ARCHITECTURAL REVIEW BOARD MEETING
CITY HALL, 385 SOUTH GOLIAD STREET, ROCKWALL, TEXAS
FEBRUARY 25, 2025 IN THE CITY COUNCIL CONFERENCE ROOM AT 5:00 PM

TO: Planning and Zoning Commission
FROM: Angelica Guevara, *Planning Technician*
DATE: February 25, 2025
SUBJECT: SP2025-002; *Amended Site Plan for an Existing Minor Automotive Repair Facility*

PROJECT NUMBER: SP2025-002
PROJECT NAME: Amended Site Plan for Discount Tire
SITE ADDRESS/LOCATIONS: 693 E INTERSTATE 30

02/21/2025: SP2025-002: Amended Site Plan for 693 E. IH-30 (Discount Tire)

SHEET #
A2.0

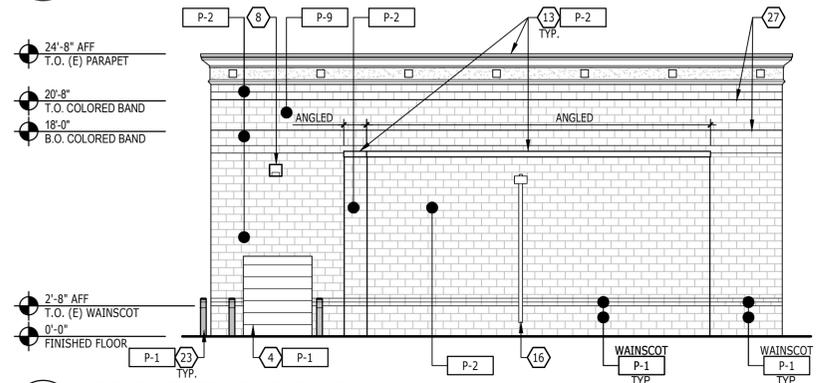
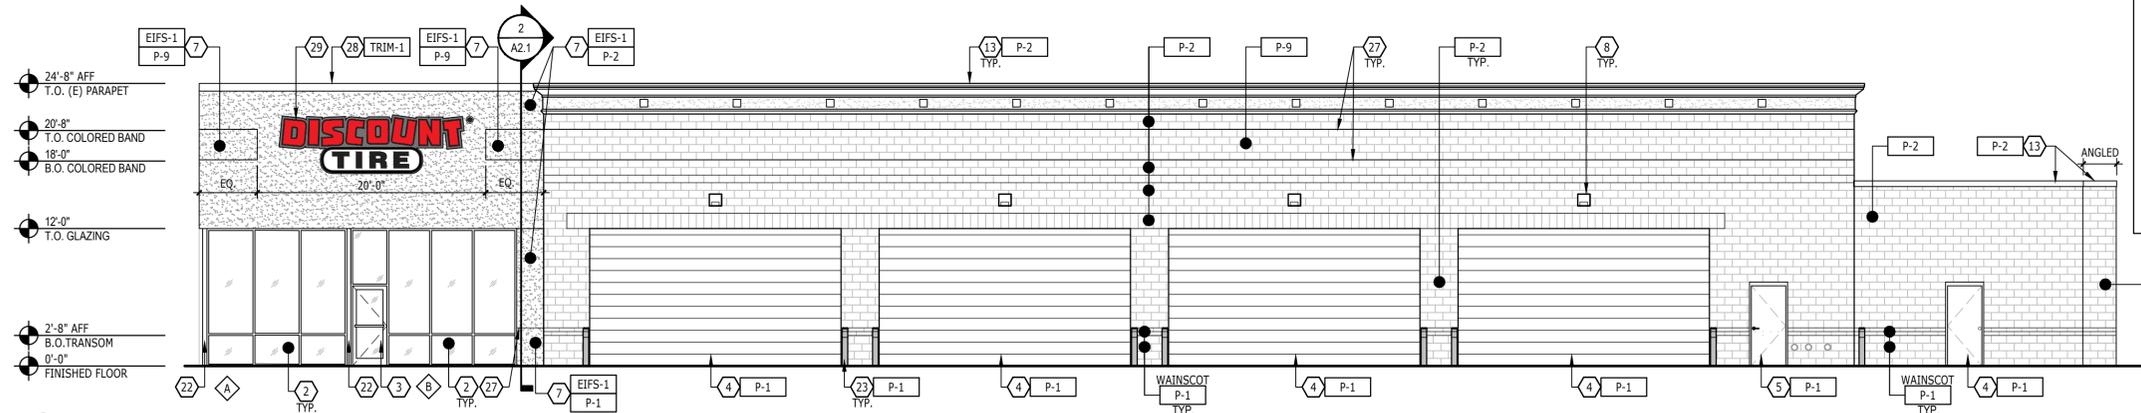
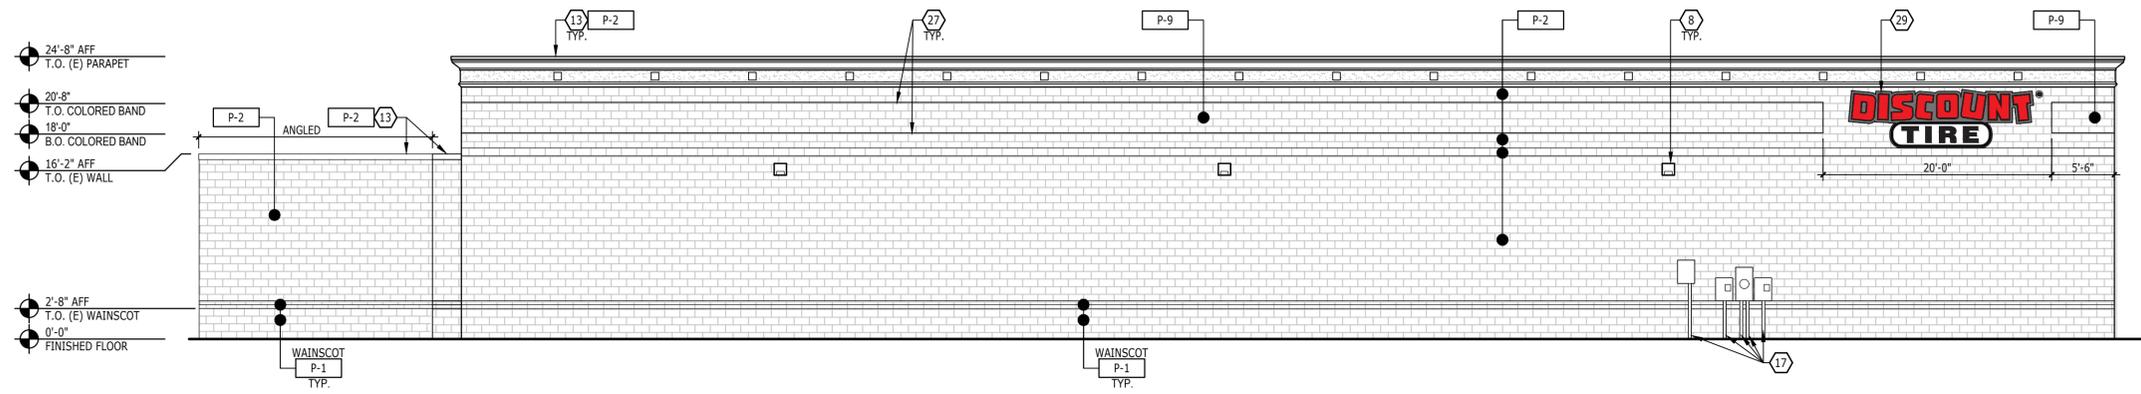
[1] *Cementitious Material*. According to Subsection 06.02, *General Overlay District Standards*, of Article 05, *District Development Standards*, of the Unified Development Code (UDC, “(t)he use of cementitious materials (e.g. stucco, cementitious lap siding or similar materials approved by the Director of Planning and Zoning or his/her designee) shall be limited to 50% of the building’s exterior façade; however, stucco shall not be used within the first four (4) feet from grade on a building’s façade.” In this case, the proposed building shows stucco being used within the first four (4) feet from grade on the north and south building facades. This will require a *variance* to be granted by the Planning and Zoning Commission.

1) Cementitious Material. According to Subsection 06.02, General Overlay District Standards, of Article 05, District Development Standards, of the Unified Development Code (UDC, "(t)he use of cementitious materials (e.g. stucco, cementitious lap siding or similar materials approved by the Director of Planning and Zoning or his/her designee) shall be limited to 50% of the building's exterior façade; however, stucco shall not be used within the first four (4) feet from grade on a building's façade. In this case, the proposed building shows stucco being used within the first four (4) feet from grade on the north and south building facades. This will require a variance to be granted by the Planning and Zoning

M.8 Please provide a variance letter that details the requested exception. In addition, "(i)n cases where an exception or exceptions is/are being requested, the applicant shall provide compensatory measures that directly offset the requested exception." Please detail the proposed compensatory measures within the exception letter. (Section 09, Article 11, UDC)

DRAWING NAME:
SITE PLAN

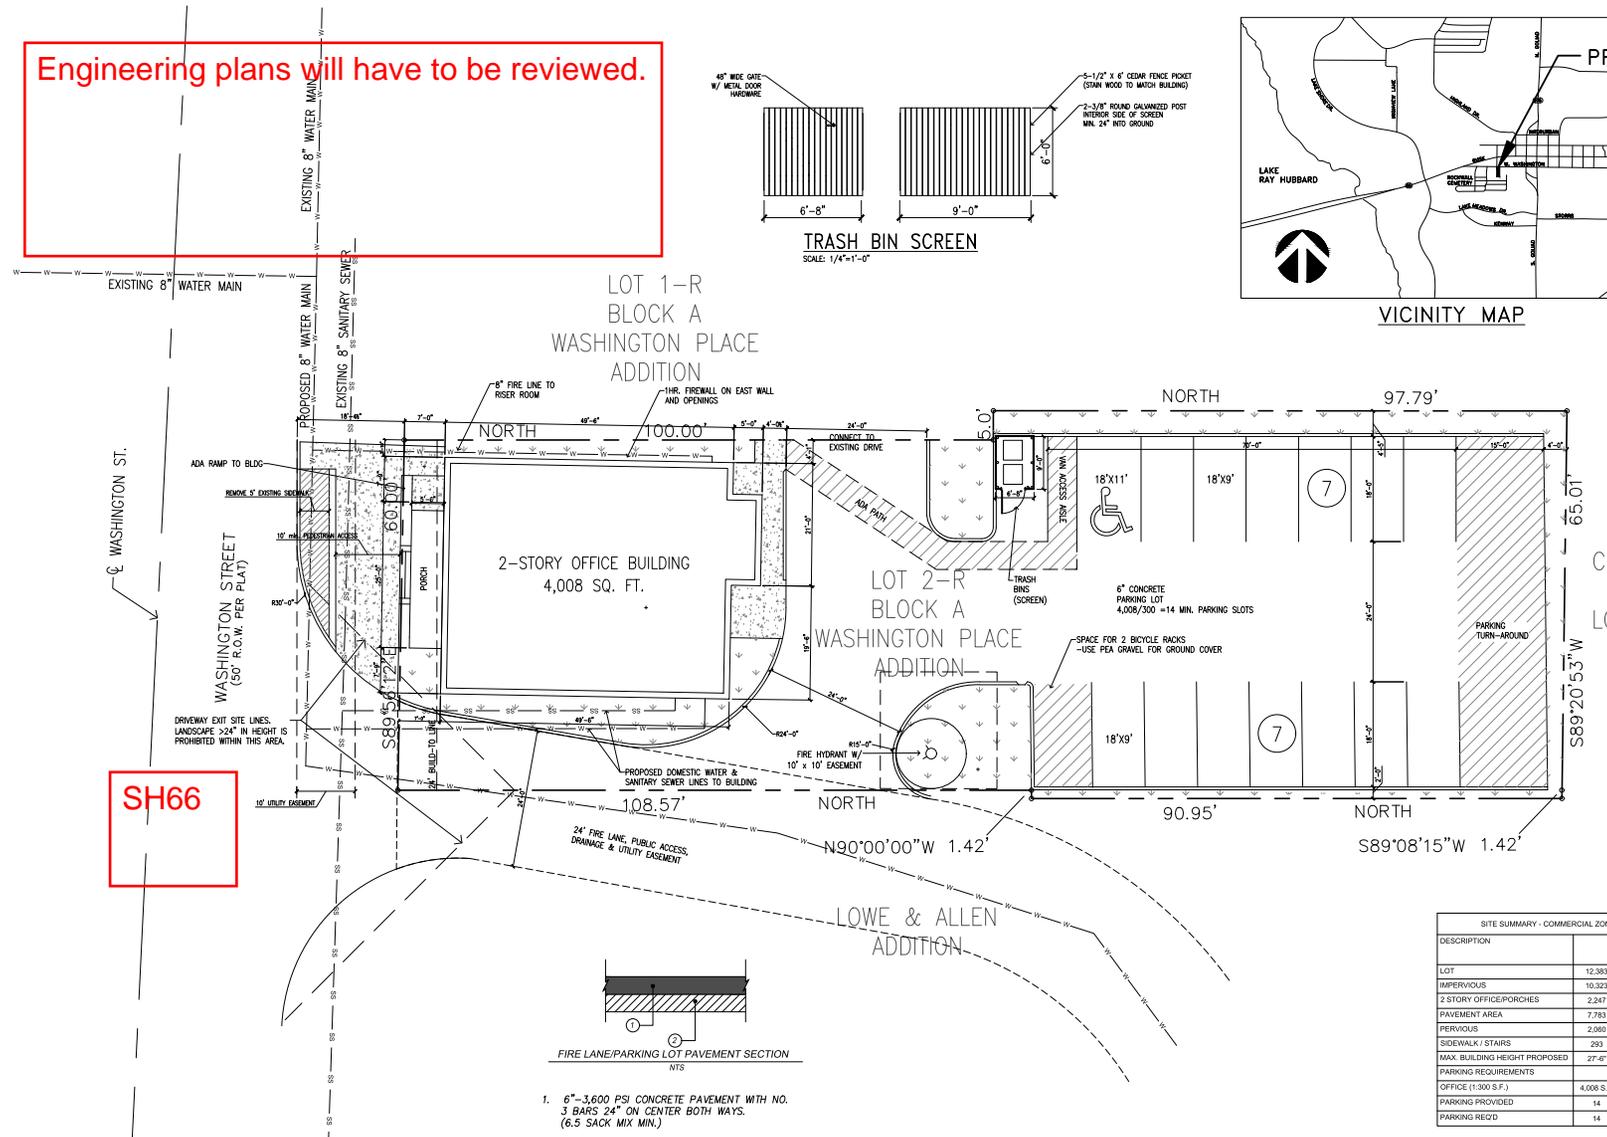
M.5 Photometric Plan. Please provide a photometric plan that meets the requirements of the UDC. The allowable maximum light intensity measured at the property line of any non-residentially zoned lot shall be 0.2 of one (1) footcandle or 0.2 FC.

Engineering plans will have to be reviewed.

A TREESCAPE PLAN

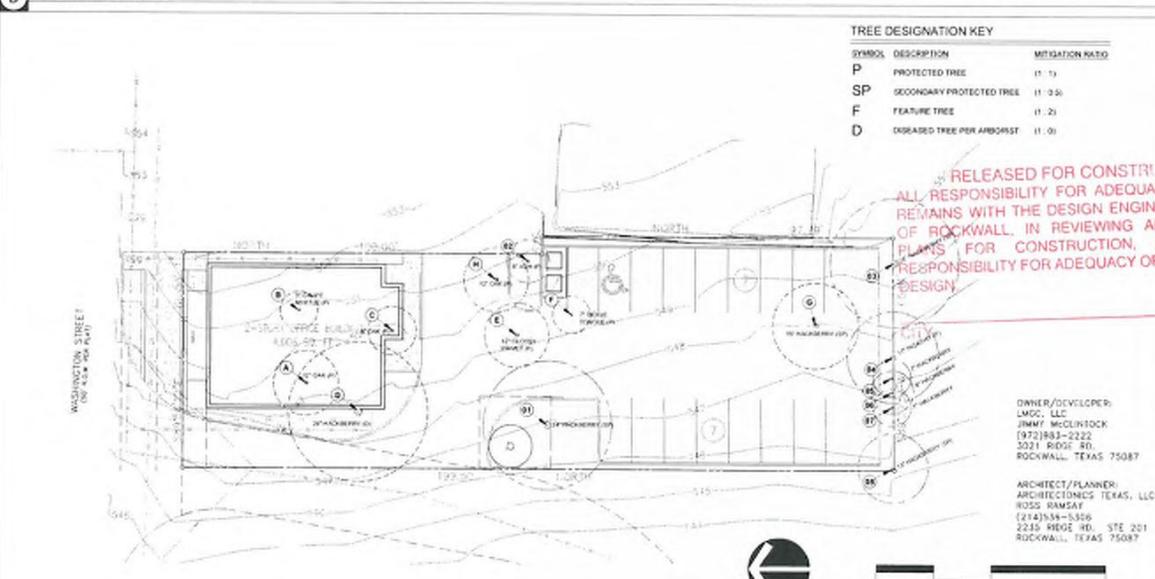
The treescape plan provided by the applicant indicates a total of 67-caliper inches to be removed from the site and the provision of one (1), six (6) inch caliper tree that counts towards the mitigation total with the proposed development. This will leave a mitigation balance due of 61-caliper inches. According to Section 05(F), of Article 09, *Tree Preservation*, of the Unified Development Code (UDC), the applicant may satisfy the tree mitigation balance by: [1] paying into the tree fund, [2] planting trees on site, and/or [3] providing the trees to the Parks and Recreation Department. In this case, the applicant has indicated their intention is to provide 20% of the mitigation balance to the City's Tree Fund totaling \$1,340.00 (i.e. 67" x 20% = 13.4" x \$100 = \$1,340.00) and providing the remaining balance of 48-inches to satisfy the mitigation balance. This has been added as a condition of approval.

- (1) All comments provided by the Planning, Engineering, and Fire Department must be addressed prior to the submittal of a building permit; and,
- (2) The applicant will be required to satisfy the outstanding balance of 48-inches of tree mitigation prior to the issuance of a building permit; and
- (3) Any construction resulting from the approval of this site plan shall conform to the requirements set forth by the Unified Development Code (UDC), the International Building Code (IBC), the Rockwall Municipal Code of Ordinances, city adopted engineering and fire codes and with all other applicable regulatory requirements administered and/or enforced by the state and federal government.

DRAWING NAME:
ELEVATIONS
 A1.0
 SP2020-017

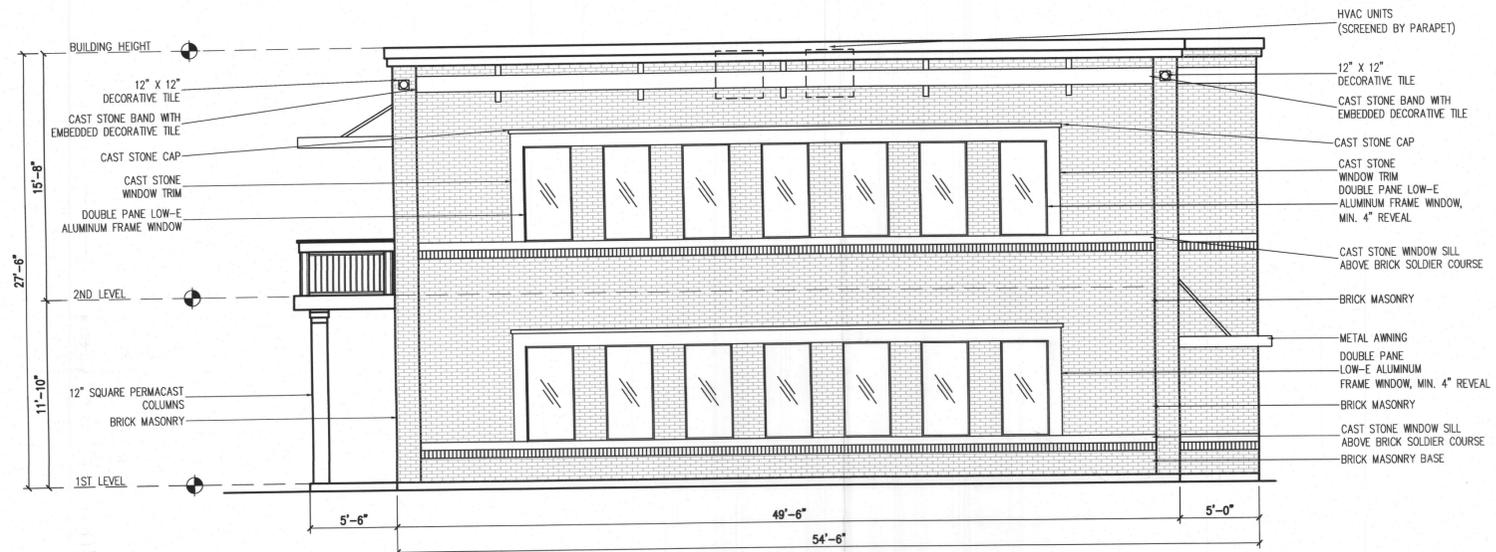
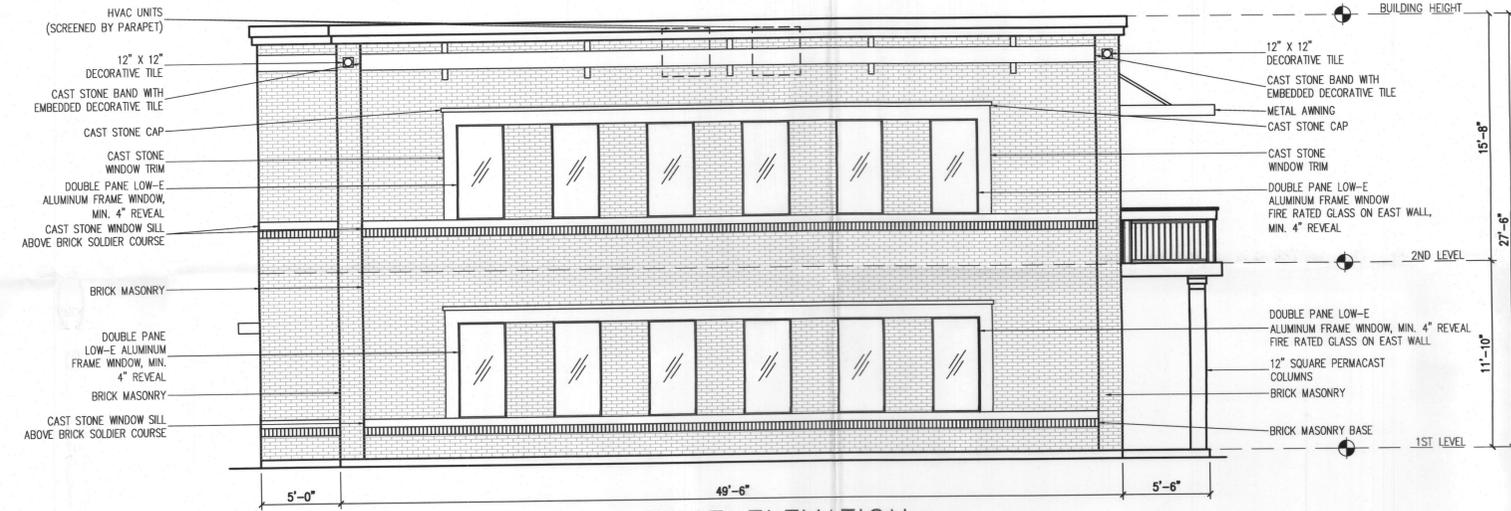
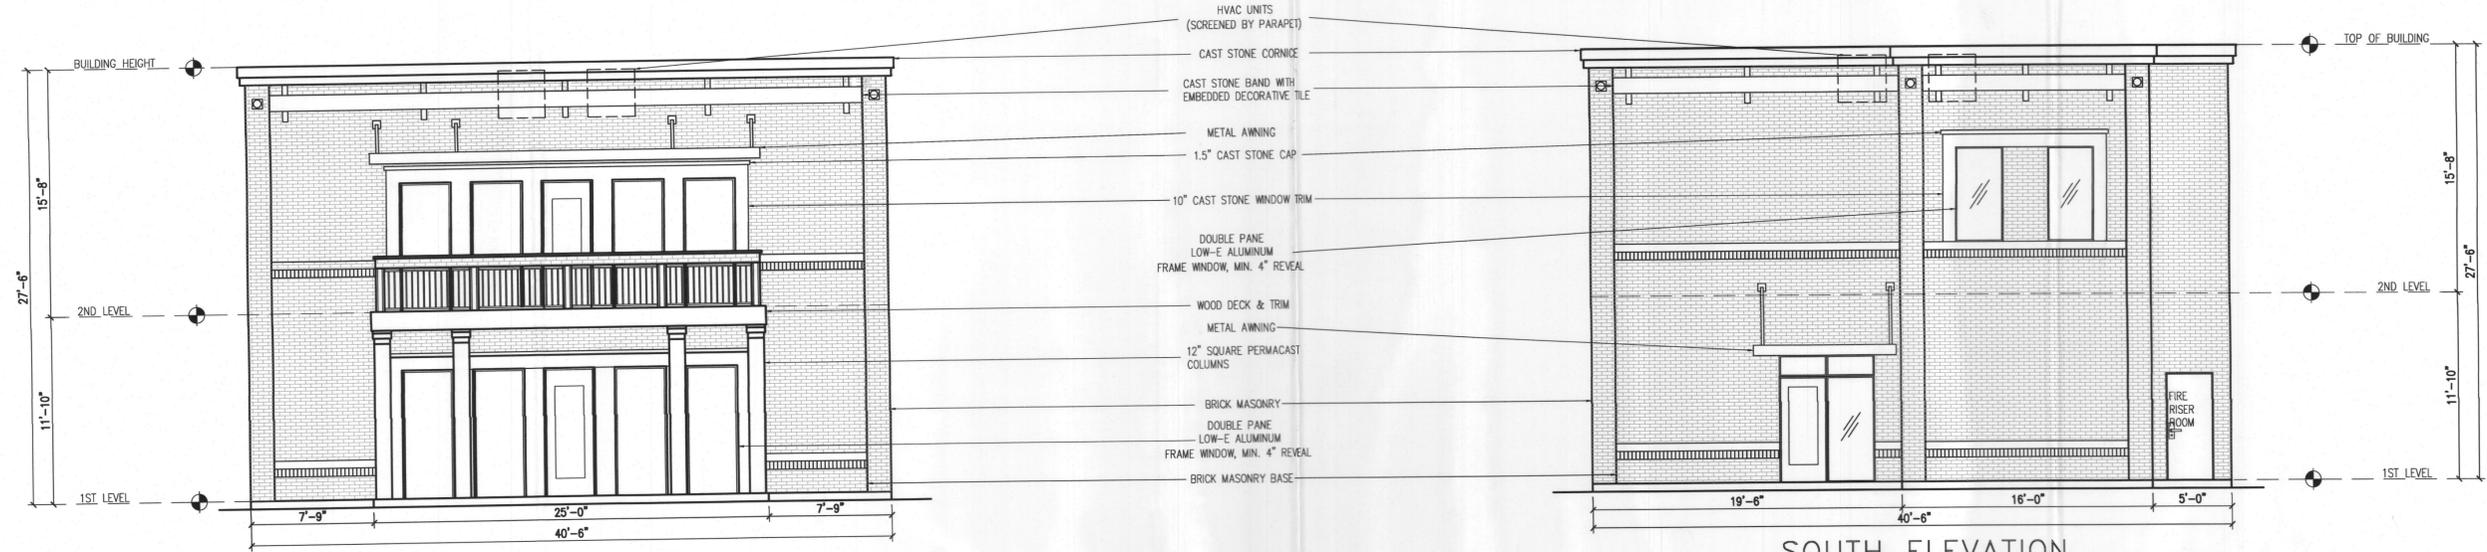
On July 28, 2020, the Architectural Review Board (ARB) reviewed the proposed building elevations and recommended that the applicant not incorporate a stone wainscot, rather use the white washed brick to meet the Downtown (DT) District's requirement of 100% brick. Additionally, the ARB recommended the columns on the front elevation be square and constructed with the white washed brick. They also recommended that the square ornamental emblems be changed to round emblems to provide more interest. The ARB will review the revisions at the August 11, 2020 meeting and forward a recommendation to the Planning and Zoning Commission.
